PŘÍKAZ K ZACHOVÁNÍ LETOVÉ ZPŮSOBILOSTI

Číslo: 2007-05-14

General Electric Company (GE)
motor CF6-80C2

Airworthiness Directives; General Electric Company (GE) CF6-80C2 Turbofan Engines

Location of Forward Engine Mount Platform and Forward Engine Mount Yoke
Figure 1

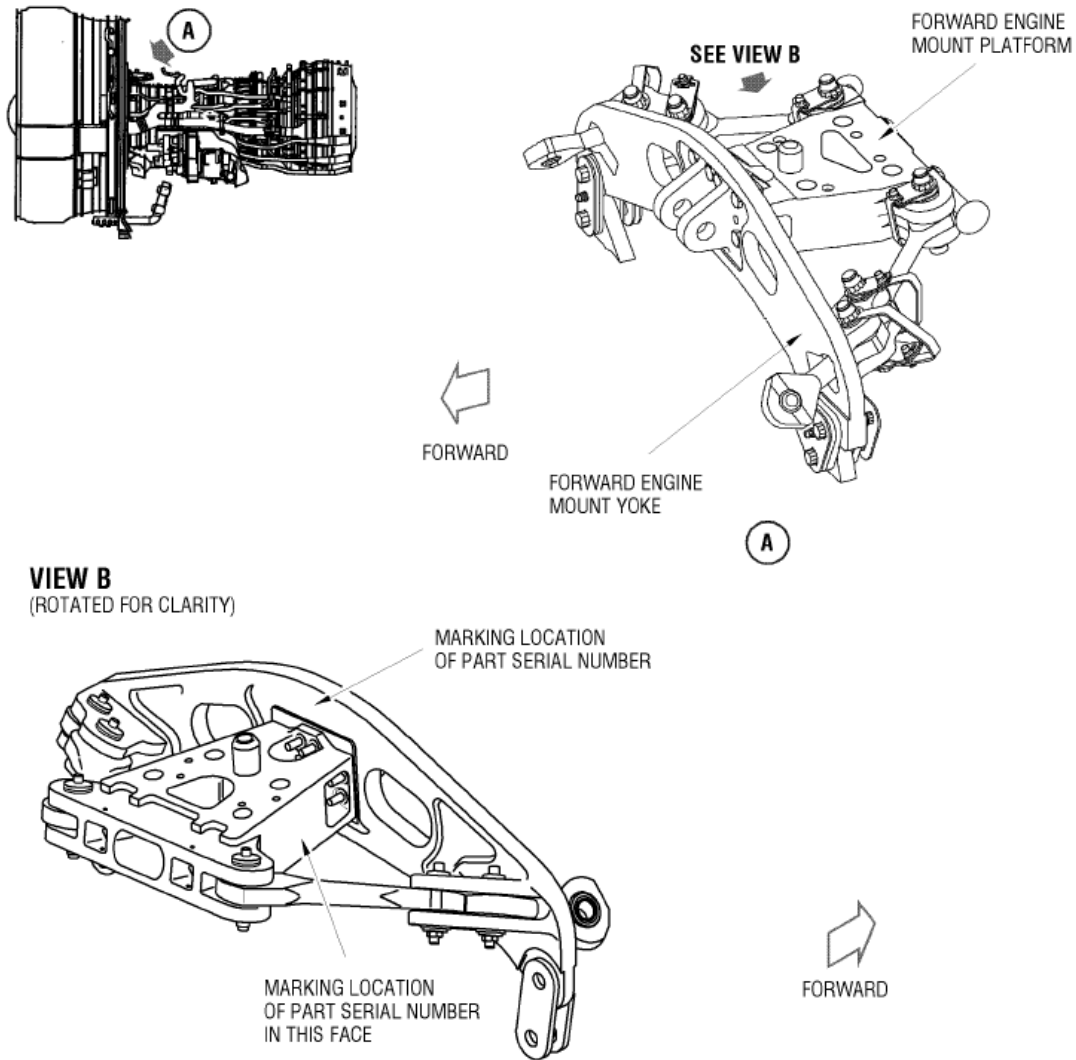
(n) Replace the affected forward engine mount platform and or the affected forward engine mount yoke with a non-weld-repaired cast titanium forward engine mount platform and or the forward engine mount yoke or a forged titanium forward engine mount platform or a forged titanium forward engine mount yoke.

(p) Location of the forward engine mount platform and forward engine mount yoke and SN are illustrated in the following Figure 1.

(q) After the effective date of this AD, do not install a weld-repaired, cast forward engine mount platform or a weld-repaired, cast forward engine mount yoke in any engine.
